TOP 3. ENTSO-E Updates

4th March 2026 – 41st GC ESC (Ljubljana)

Juan Giner (ENTSO-E) – Grid Connection Specialist

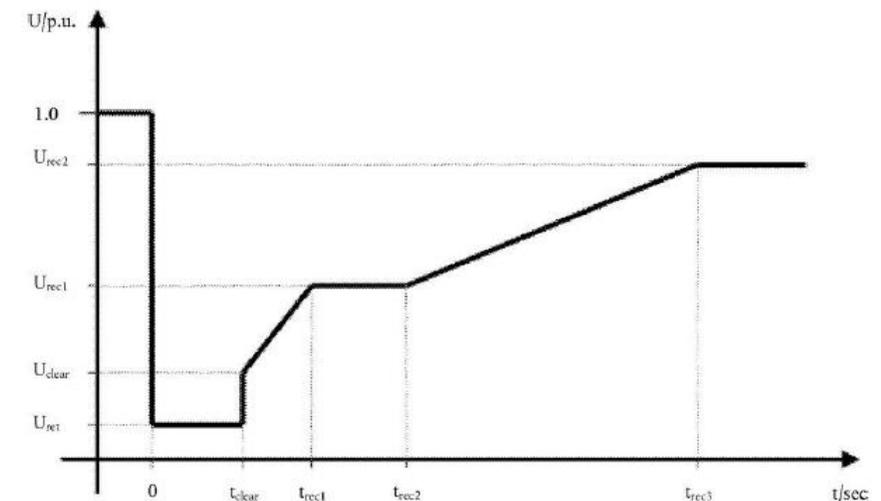
- Besides, Art. XX(1) is **not in line with Art. 13(12) of draft NC RfG 2.0**, where voltages below 110 kV are considered
 - Art. XX(1) is as follows:** (b) be capable of remaining connected to the network and operate continuously within the range of **0,85 pu - 1,1 pu** at the connection point. Beyond these voltage range values, the under-voltage ride through immunity limits apply.

- Art. 13(12) of draft NC RfG 2.0 is as follows:** ... shall be capable of remaining connected to the network and operate continuously within the range of **0,85 pu - 1,1 pu** at the connection point should that be **at or below 1000V**. Conversely, the power-generating module shall be capable of remaining connected to the network and operate continuously within the range of **0,9 pu - 1,1 pu** at the connection point should that be **above 1000V and below 110 kV**.

- Consequently, **Urec2 in the fault-ride-through** curve of draft NC DC 2.0 should also be adapted, which is currently 0.85 pu
- Consequently, the **post-fault recovery** of draft NC DC 2.0 should also be adapted. Currently:

When the network voltage resumes, after the fault has been cleared, to a value within the voltage range of 0,85 pu – 1,1 pu...
